TAX ID # 05450233
ON-SITE SEWAGE DISPOSAL SYSTEM
HOWARD COUNTY HEALTH DEPARTMENT
BUREAU OF ENVIRONMENTAL HEALTH

SUBDIVISION: Brighton Mill LOT NUMBER: 21

Approved Septic System Plan
Howard County Health Department

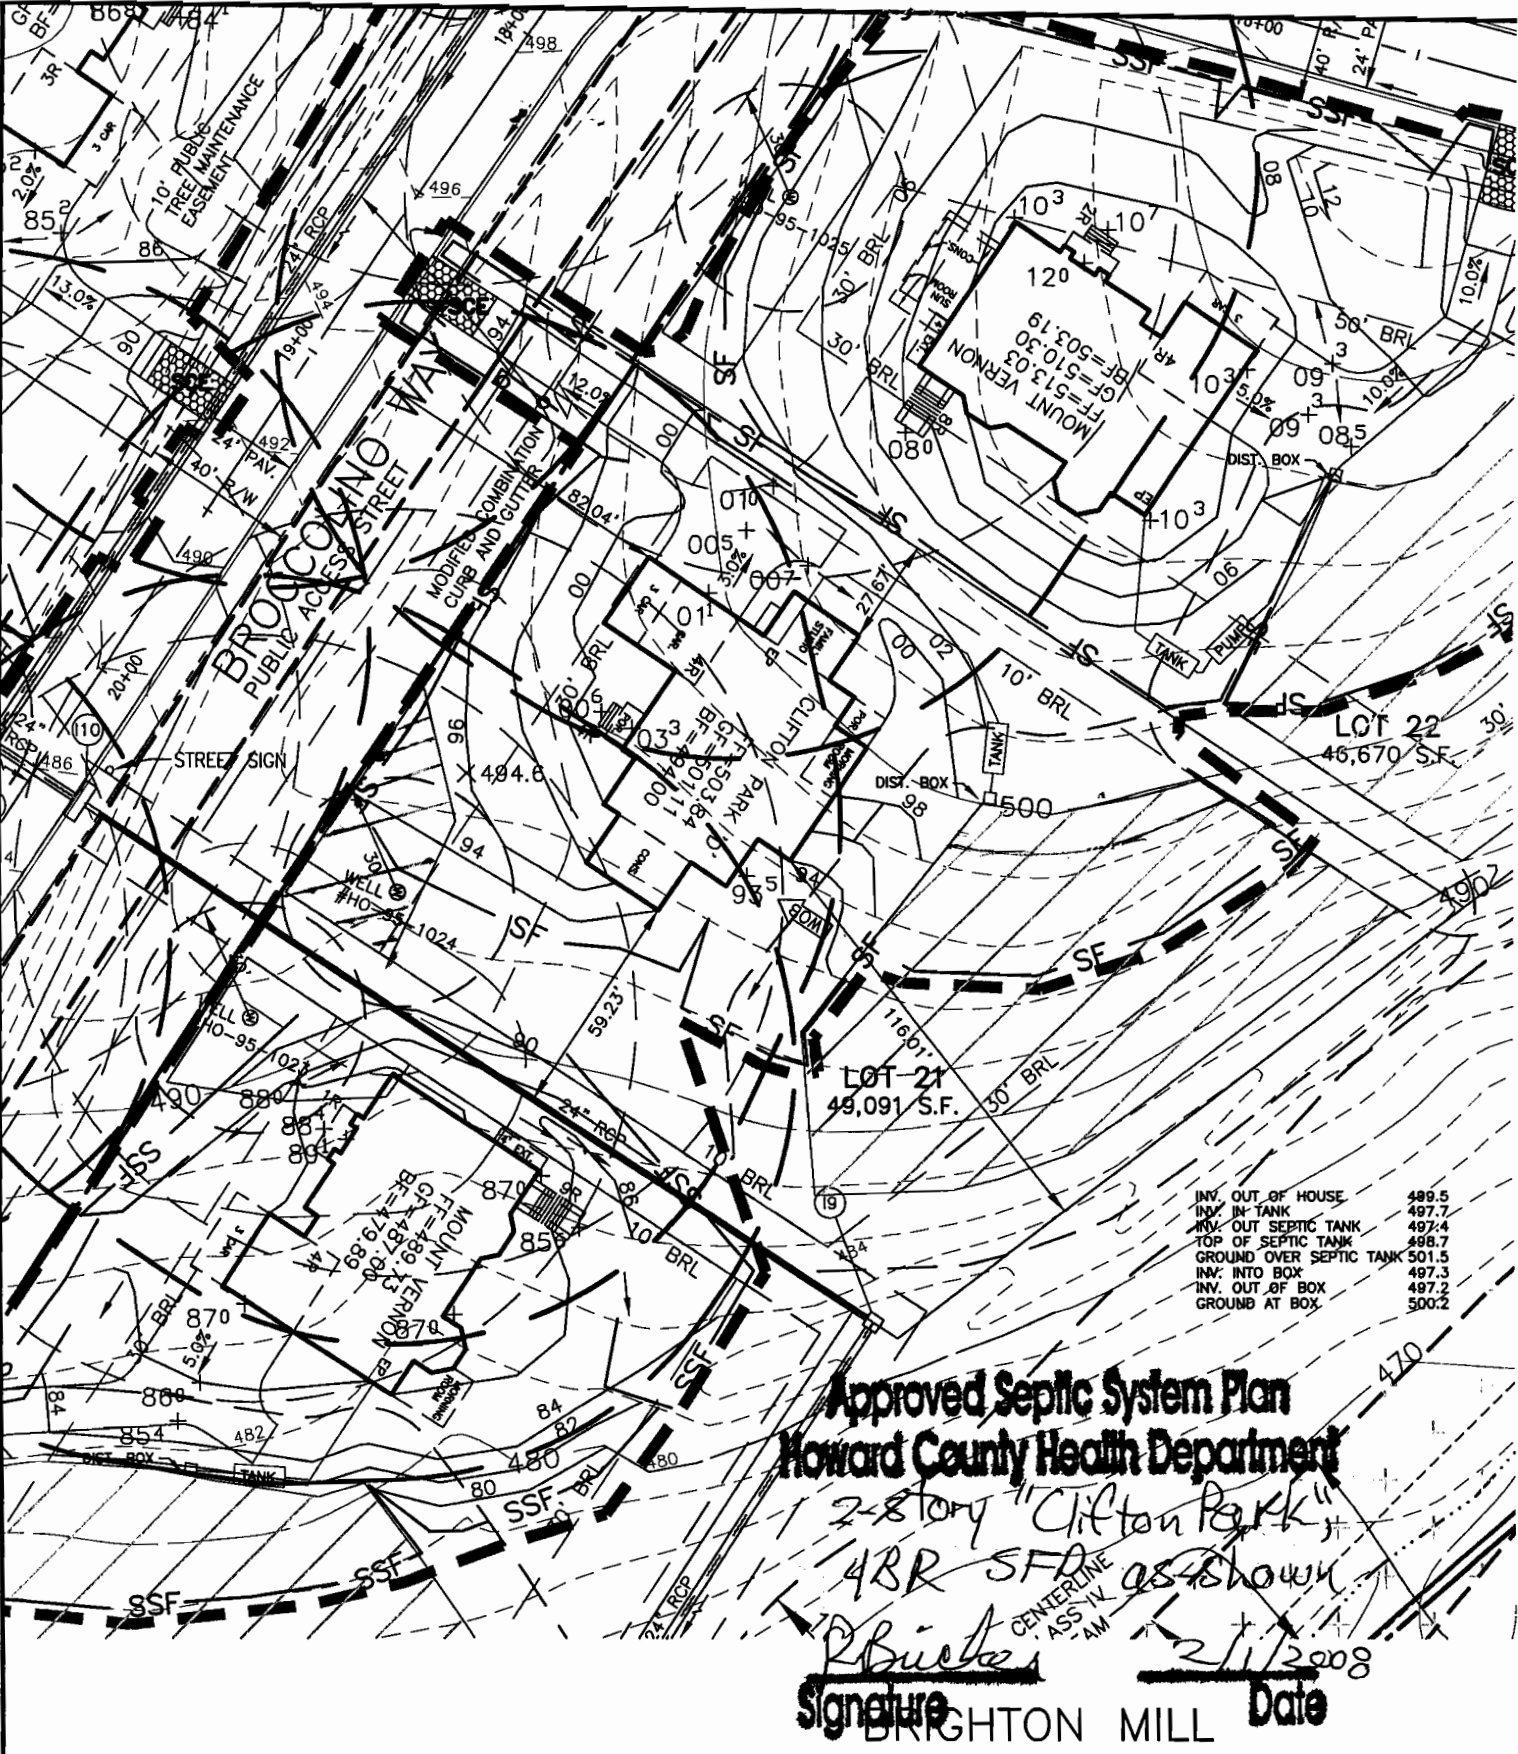
PRE-CONSTRUCTION 3/19/08 Trench locations painted in field.
 INSTALLATION easement and a 65' trench directly below it.
 Put tank close to where shown on plan and not in swale. (BB) 3/20/08 Trenches finished. Need fabric on top of gravel. Need baffle and levelers in dist. box. (BB) 3/21/08 system finished. Told contractor to add c/o @ house. Need house correction for final approval. Septic tank from 'baystar' needs to meet howard co. code. OK to back fill (KW)

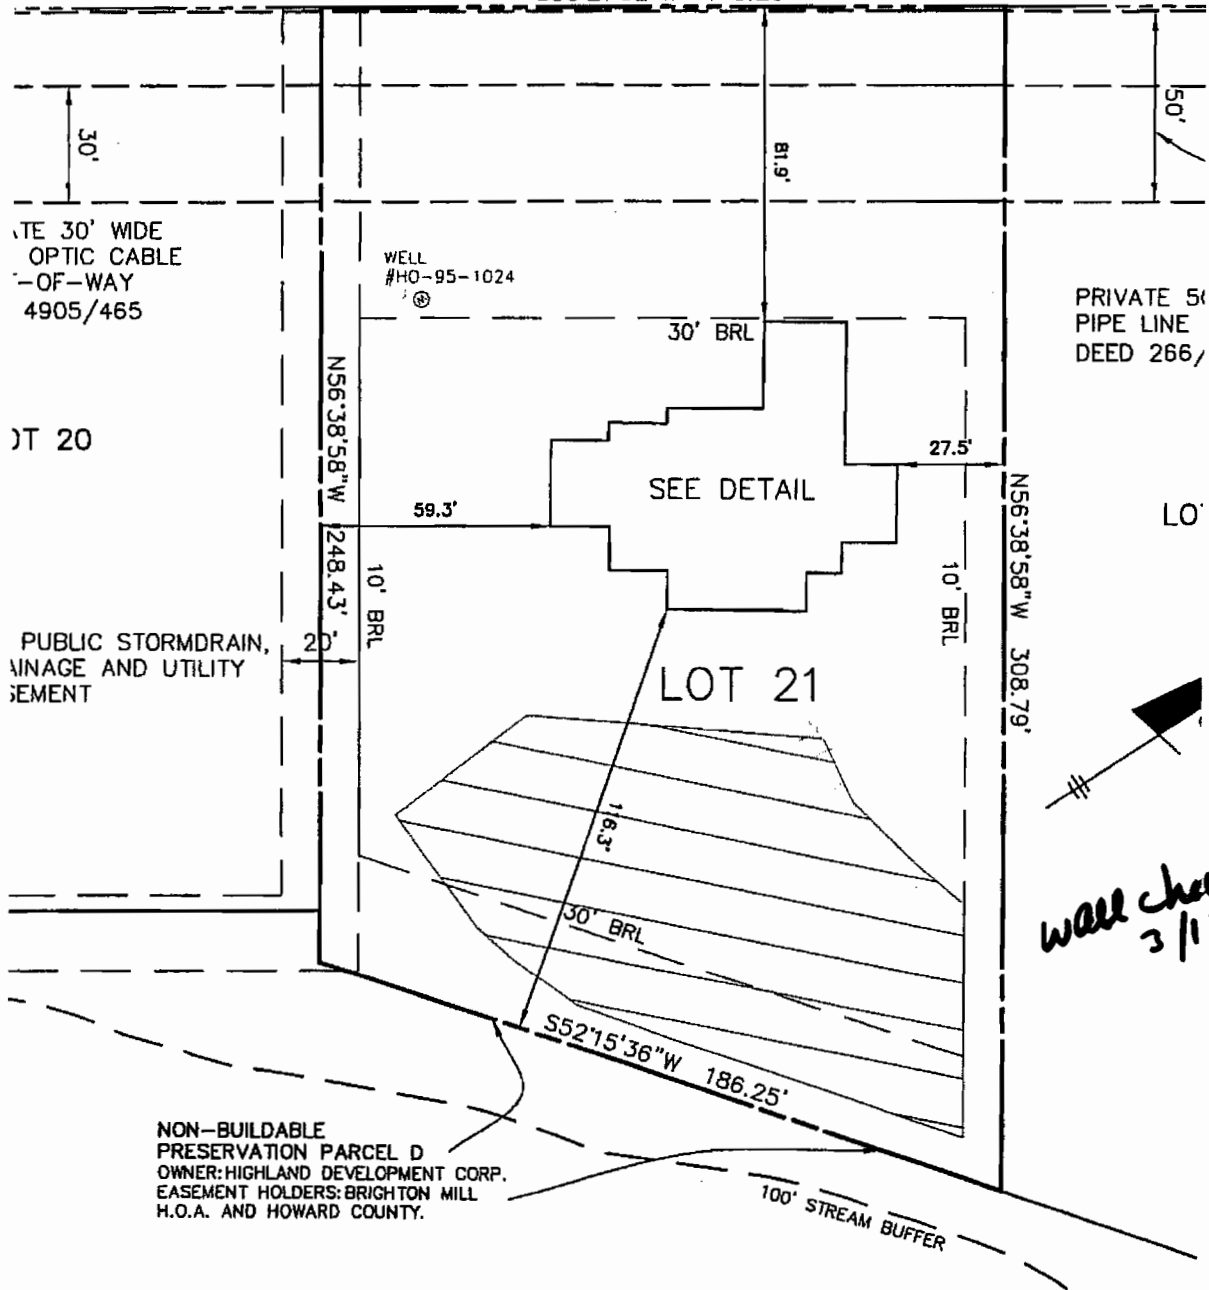
Done 1/17/08

*Wall check ok
3/18/08
SP*
